# Memorandum to the City of Markham Committee of Adjustment

**File:** A/34/19  
**Address:** 15 Francesco Court, Markham  
**Applicant:** Edison Chong  
**Agent:** Thomas Yeung  
**Hearing Date:** Wednesday June 26, 2019

a) **Deck By-law 142-95, Section 2.2(b)(i):**

a maximum deck projection of 4.98 m, whereas the By-law permits a maximum projection of 3.0 m; as it relates to a rear yard deck extension that was built without a building permit.

**LANDSCAPE AND PLANTING PLAN (A)**

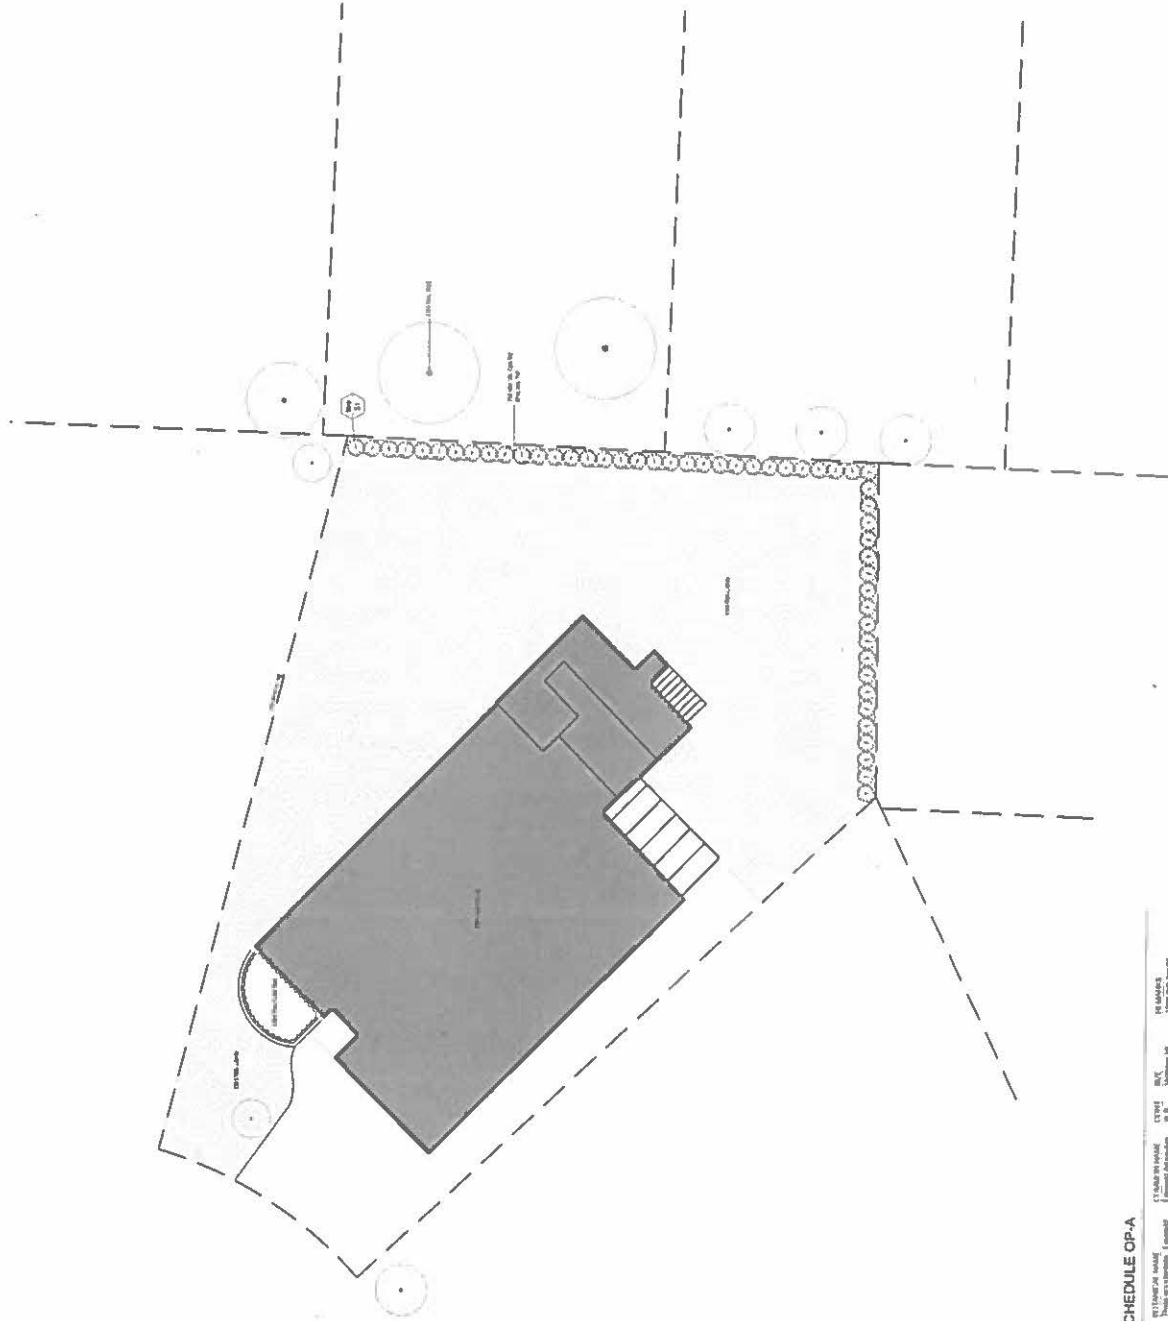
The Committee of Adjustment deferred this application on May 8<sup>th</sup>, 2019 requesting that the applicant prepare landscape plans. The applicant submitted a landscape plan on June 10<sup>th</sup>, 2019 (Appendix A1) which addresses privacy concerns by adding screening through the introduction of cedar trees along the rear property line. The applicant has not revised their variances nor submitted revised deck drawings. Staff's comments, conditions and drawings attached as appendix 'A2' remain applicable subject to the landscape plans attached (Appendix A1).

DRAWING TITLE:  
SW ELEVATIONS:  
BEFORE AND AFTER  
EXTENSION

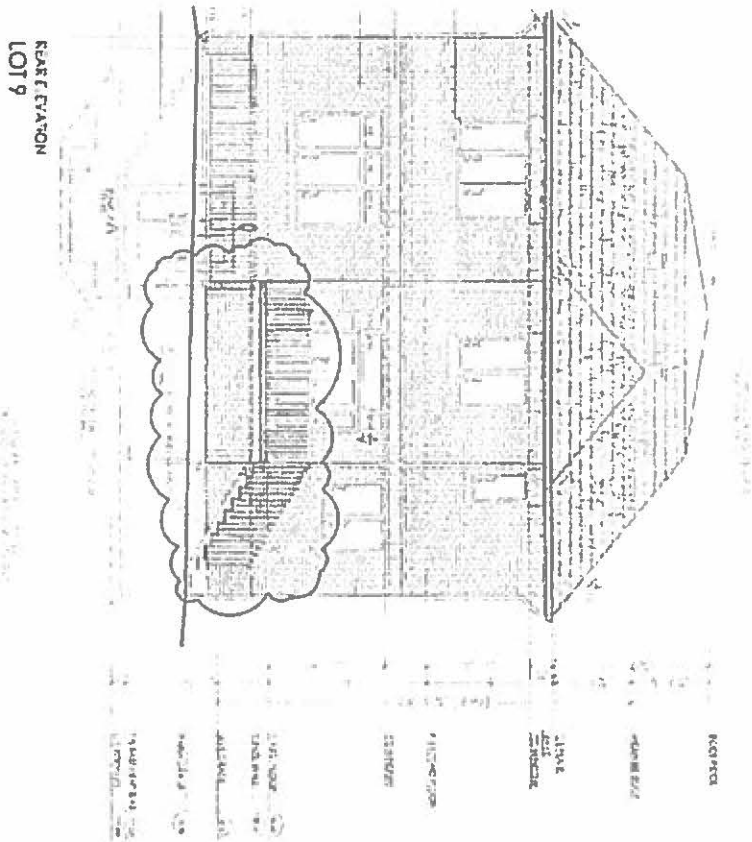
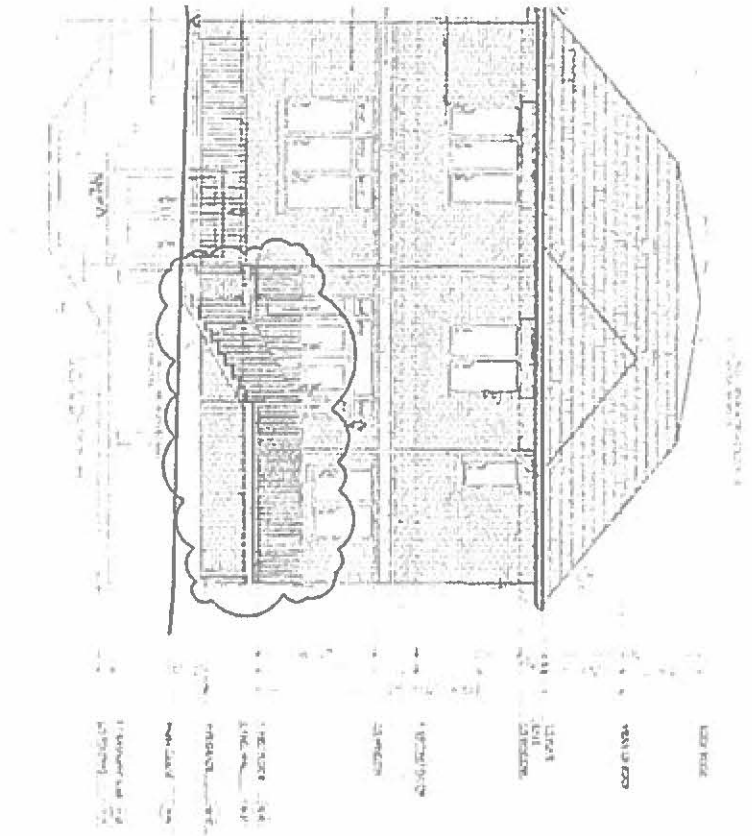
The applicant is requesting a maximum deck projection of 4.98 m (16.34 ft), whereas the By-law permits a maximum deck projection of 3.0 m (9.84 ft). This represents an increase of approximately 1.98 m (6.5 ft). It should be noted that a ZPR has not been conducted. Located on an irregularly shaped lot, the deck will provide a rear yard setback of approximately 7.5 m (24.96 ft). Side yard setbacks of approximately 12.16 m (39.92 ft) on the right (north) side and over 2.4 m (7.91 ft) on the left (south) side of the existing dwelling will be maintained. Given that the proposed deck will be unenclosed and uncovered, the side yard setbacks and, the required rear yard setback is met, staff have no objection.

1. That the proposed deck remain uncovered and unenclosed;
2. The variances apply only to the existing development as long as it remains;
3. That the variances apply only to the subject development, in substantial conformity with the plan(s) attached as 'Appendix B' to this Staff Report and received by the City of Markham on April 11, 2019, and that the Secretary-Treasurer receive written confirmation from the Director of Planning and Urban Design or designate that this condition has been fulfilled to his or her satisfaction.
